Amendments to the 2018 International Swimming Pool and Spa Code

The following sections, paragraphs, and sentences of the *2018 International Swimming Pool and Spa Code* are hereby amended as follows: Standard type is text from the ISPSC. <u>Underlined type is text inserted.</u> <u>Lined through type is deleted text from ISPSC.</u> A triple asterisk (***) identifies a new or revised amendment with the *2018 ISPSC* code.

ADD: Figure: 25 TAC §265.186 (e) (6)

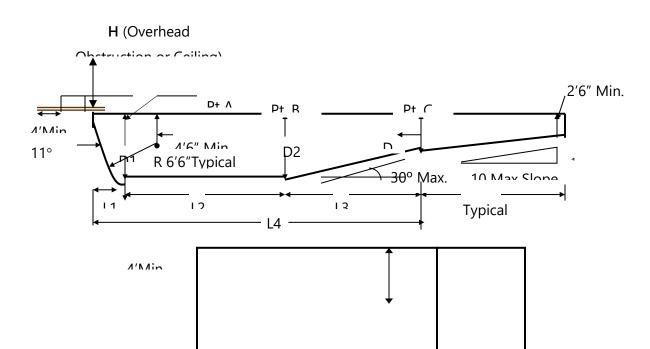
402.12 Water envelopes. The minimum diving water envelopes shall be in accordance with Table 402.12 Texas department of State Health services, Administrative Code Title 25, Chapter 265, Section 186 (e) and Figure: 25 TAC 256.186 (e) (6). (Delete Table 402.12 and Figure 402.12)

^{**} Section 402.12; Change to read as follows:

Maximum Diving Board Height Over Water	3/4 Meter	1 Meter	3 Meters
Max. Diving Board Length	12 ft.	16 ft.	16 ft.
Minimum Diving Board Overhang	2 ft. 6 in.	5 ft.	5 ft.
D1 Minimum	8 ft. 6 in.	11 ft. 2 in.	12 ft. 2 in.
D2 Minimum	9 ft.	10 ft. 10 in.	11 ft. 10 in.
D3 Minimum	4 ft.	6 ft.	6 ft.
L1 Minimum	4 ft.	5 ft.	5 ft.
L2 Minimum	12 ft.	16 ft. 5 in.	19 ft. 9 in.
L3 Minimum	14 ft. 10 in.	13 ft. 2 in.	13 ft. 11 in.
L4 Minimum	30 ft. 10 in.	34 ft. 7 in.	38 ft. 8 in.
L5 Minimum	8 ft.	10 ft.	13 ft.
H Minimum	16 ft.	16 ft.	16 ft.
From Plummet to Pool Wall at Side	9 ft.	10 ft.	11 ft. 6 in.
From Plummet to Adjacent Plummet	10 ft.	10 ft.	10 ft.

(Reason: To avoid conflict with 25 TAC Chapter 265.)
